# Sheringham Shoal and Dudgeon Offshore Wind Farm Extension Projects

Apportioning and HRA Updates Technical Note  
(Revision E) (Clean)

Document Reference: 13.3

Table 5-2: Natural England consultation summary (Based on Rev B Note [REP2-036] at Deadline 3, received May 2023)

Title: Figure 1 Overlap of SEP 10km buffer (in 1km increments) with Greater Wash SPA and area outside Red-throated Diver MCA (from Lawson et al., 2016)

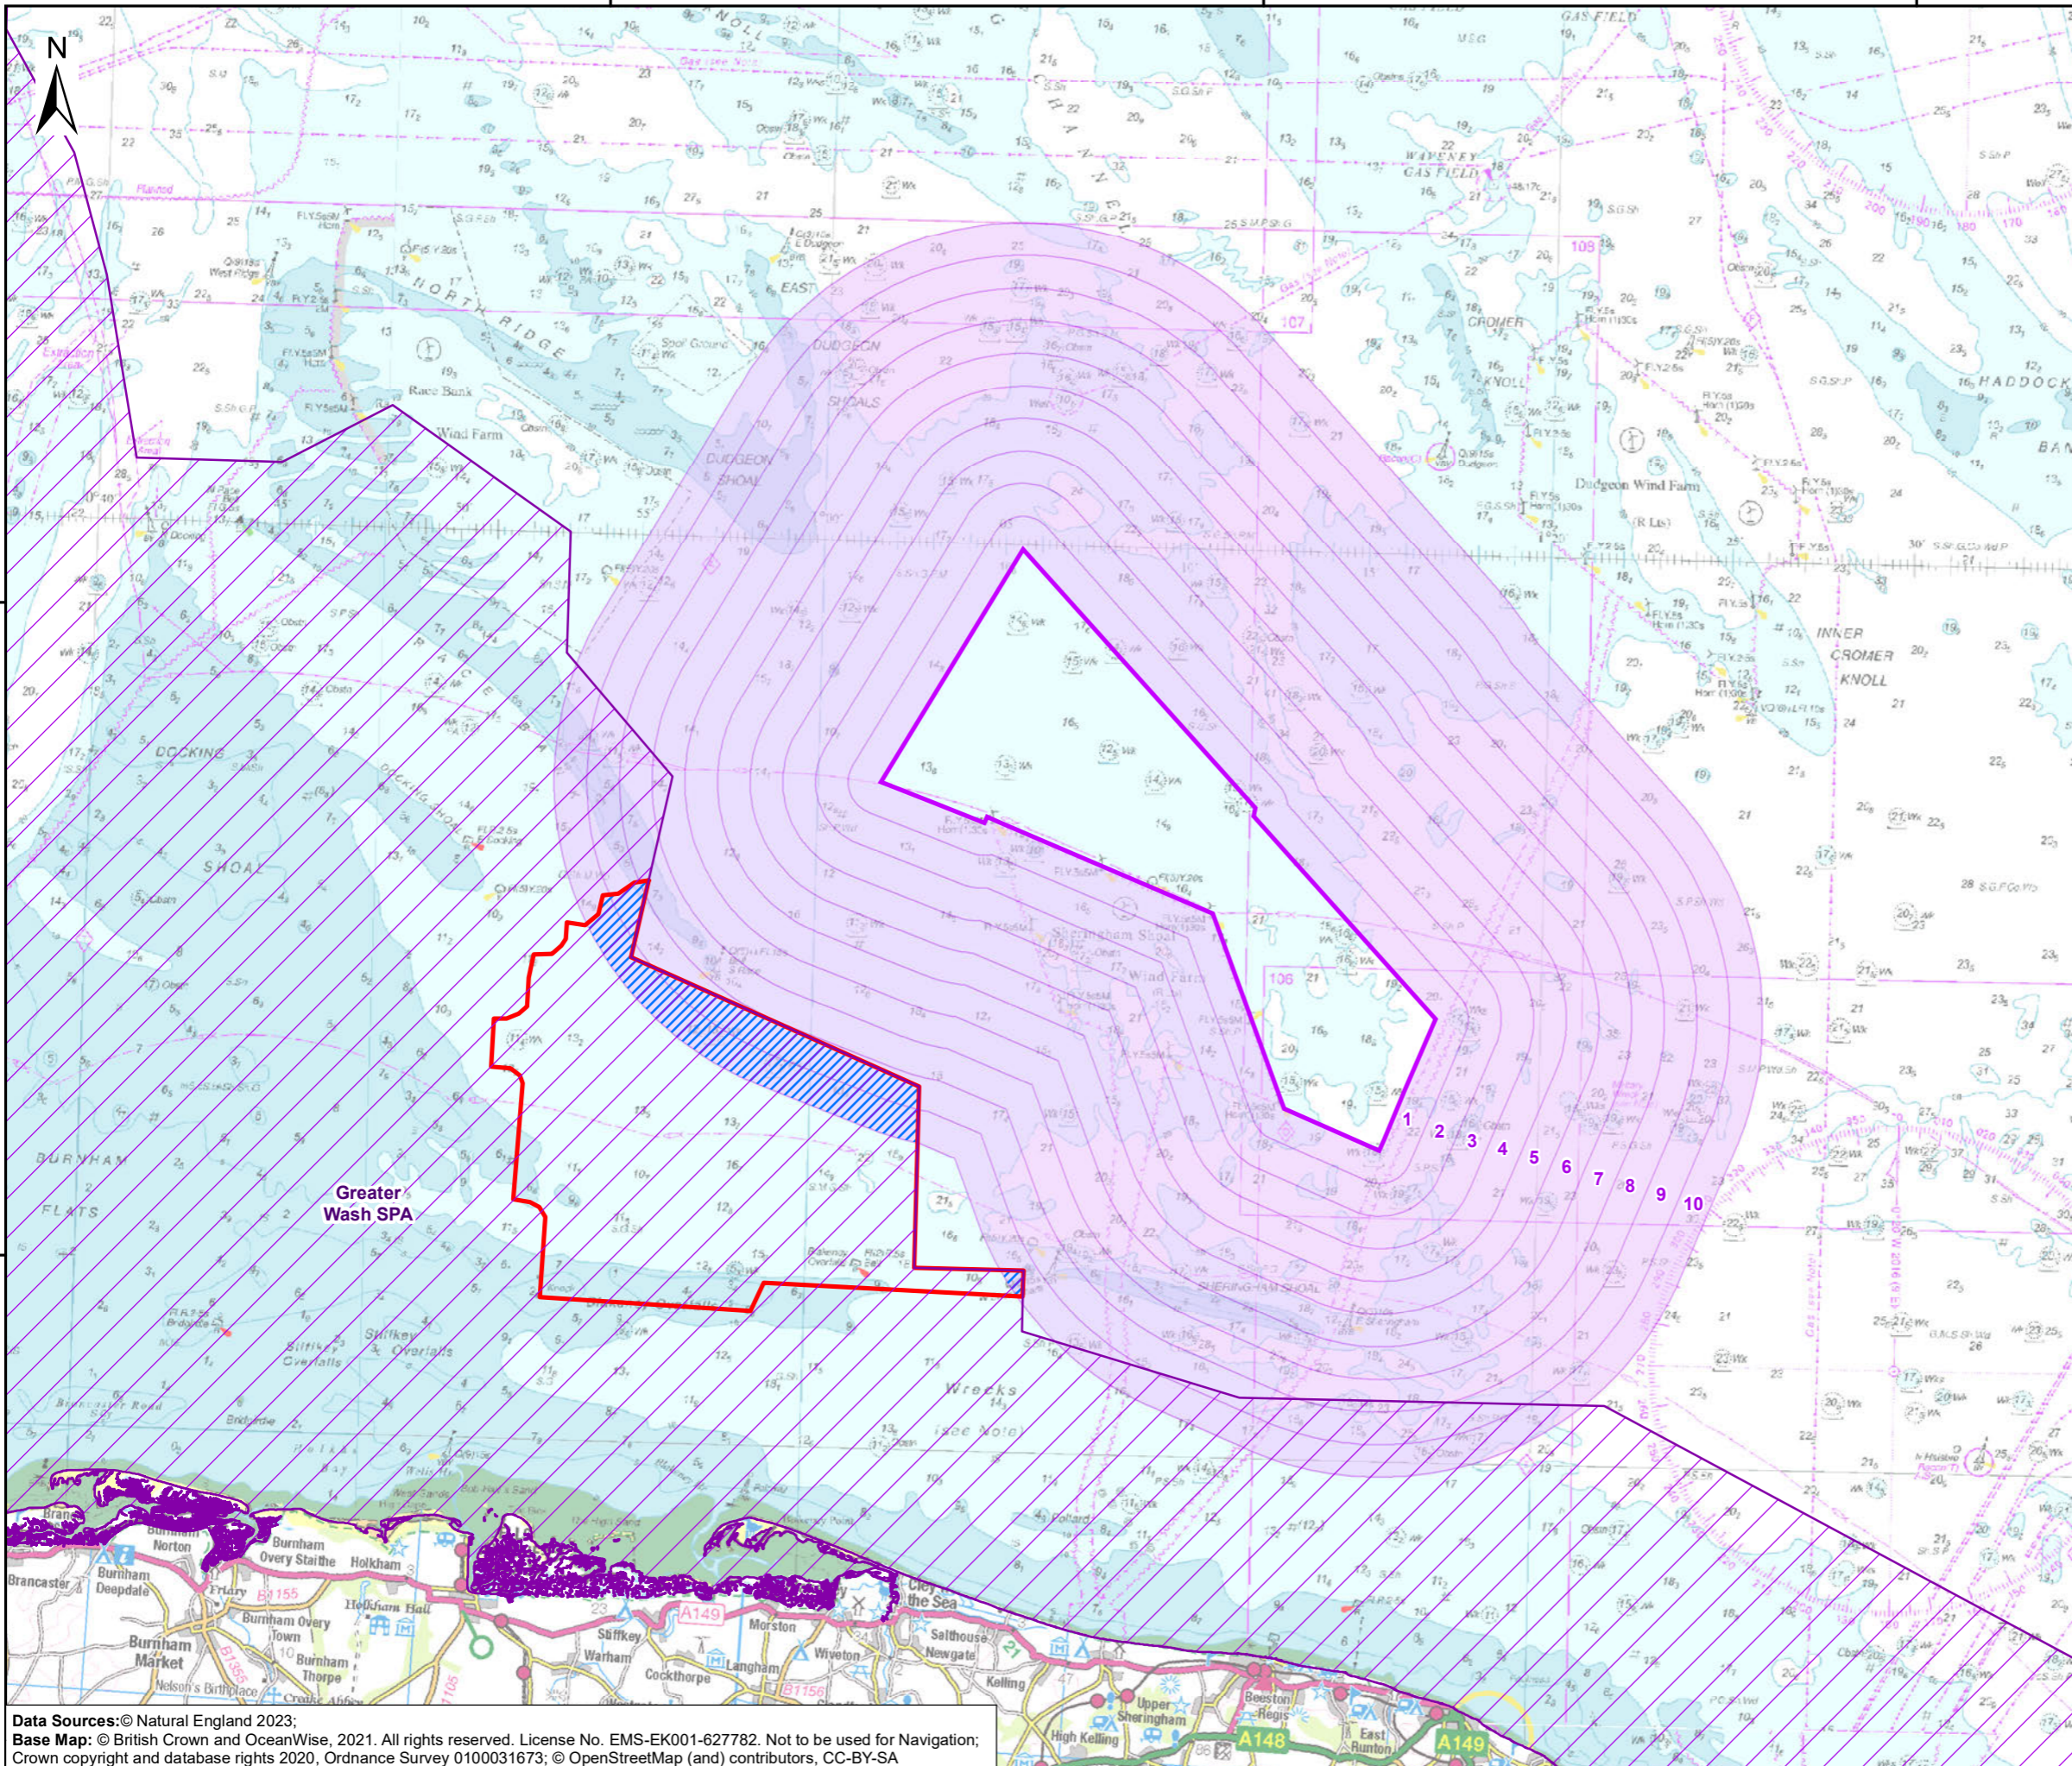
17	11. GW SPA RTD	91	<p>A) We recognise that parts of the Greater Wash SPA fall outside the area identified by Maximum Curvature Analysis (MCA) as being the most suitable parts of the SPA for RTD. MCA was used to identifying the areas important to each relevant species, a composite of which was then used to determine the boundary of the SPA. However, whilst it is reasonable to say that these areas are less important to RTD than other parts of the site, we do not consider that the area should be entirely excluded from estimates of the displacement area for this species. We highlight that RTD were recorded in this area during the classification surveys, and furthermore, that recent digital aerial surveys of the GW SPA conducted in October 2022 show the presence of RTD in this area. outside the RTD MCA. Therefore, Natural England's assessment of potential impacts does include</p>	<p>A) Noted</p> <p>B) Clarification regarding the need for vessels to transit to and from the export cable laying site during installation is provided in <a href="#">Section 14.2.1</a>.</p>

ID	Section of draft document	Paragraph	Natural England comment	Applicant response
			<p>some consideration of the area that falls beyond the MCA line, albeit with the caveats noted above. It is therefore helpful that the Applicant has provided displacement area/SPA % values including as well as excluding this area.</p> <p>B) Natural England note that potential impacts from construction vessels transiting to and from the cable corridors have not been considered within the assessment, presumably due to the fact that the construction port(s) will not be confirmed until nearer the start of construction. However, Natural England consider that due to the fact that use of a port adjacent to either the Greater Wash SPA or Outer Thames is plausible, some further consideration of the possible impacts from construction vessels transiting to and from the ECC should be undertaken.</p>	
18	11. GW SPA RTD	Figures 1 & 2	The legends for Figures 1 and 2 incorrectly show the boundary of the RTD MCA and the area where SEP's buffer zone overlaps the RTD MCA.	The legends for <b>Figure 1</b> and <b>Figure 2</b> have been updated.

106. Updated estimates have also been calculated for the area within the SPA within which displacement could occur, based on Natural England's new displacement rates. Minor changes to the areas used for this calculation have all been used in the updated estimates, based on revised GIS analysis (**Appendix 3**). Two estimates have been presented; the first uses the same approach as the **RIAA** [APP-059]. The second uses information presented within the Departmental Brief for GW SPA (Natural England and JNCC, 2016) and which at a meeting on 15 November 2022 the Applicant was recommended by Natural England to investigate further. This method excludes an area of the SPA that is outside of the Maximum Curvature Analysis (MCA) for red-throated diver. The MCA is presented in the Departmental Brief (Natural England and JNCC, 2016) and identifies the areas where significant densities of red-throated diver are likely to be present, based on data presented in Lawson *et al.* (2016). This information contributed to determining the SPA boundary. A section of the GW SPA, which is also within 10km of SEP, lies outside the MCA for red-throated diver (**Figure 1**), i.e. the section of the SPA which was designated

on the basis of a different qualifying species (little gull) and not on the basis of the distribution of red-throated diver. As this area lies outside the zone designated for red-throated diver within the GW SPA, it is considered reasonable to exclude it from the estimate of the displacement area for this species (see [Figure 1](#)).
